**RE: Blanchardstown to City Centre Core Bus Corridor Scheme,
Compulsory Purchase Orders BG1, BG2, BF1, BF2
Case Reference: KA29N.313961**

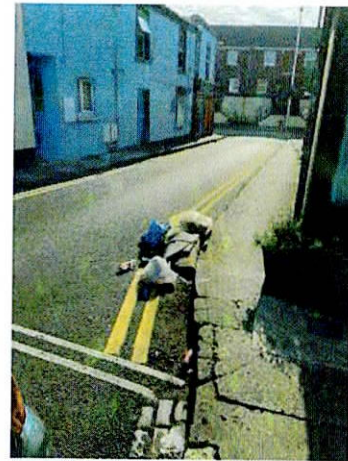
Currently there is a rat run for commuter traffic off the NCR through Monck Place and Avondale Avenue in order to avoid the queue to Doyle's Corner and turn Southbound onto Phibsborough Road. The measures proposed via the CPOs do mitigate the rat run on Monck Place and to a lesser degree Avondale Avenue as with only a left turn on to Phibsborough Road the rat run Southbound will be reduced. With the proposed removal of any turn off Phibsborough Road into both Monck Place and Phibsborough then the rat run is further deterred however this also makes neighbourhood access for residents extremely difficult.

The removal of a right turn on to Phibsborough Road from either Monck Place or Phibsborough does mitigate one of the two major rat runs that exists. The second major rat run off Phibsborough Road through Monck Place and Avondale Avenue is from Northbound traffic and we would agree this should be removed or better restricted to local traffic. However, at a minimum, Southbound traffic should still be allowed to turn into Monck Place as this is largely used by local traffic / residents because Southbound traffic seeking Westward access on to the NCR do so via Connaught Street. We believe there is an unnecessarily high burden being placed on Connaught Street and its residents which the removal of a Southbound access to Monck Place will exacerbate.
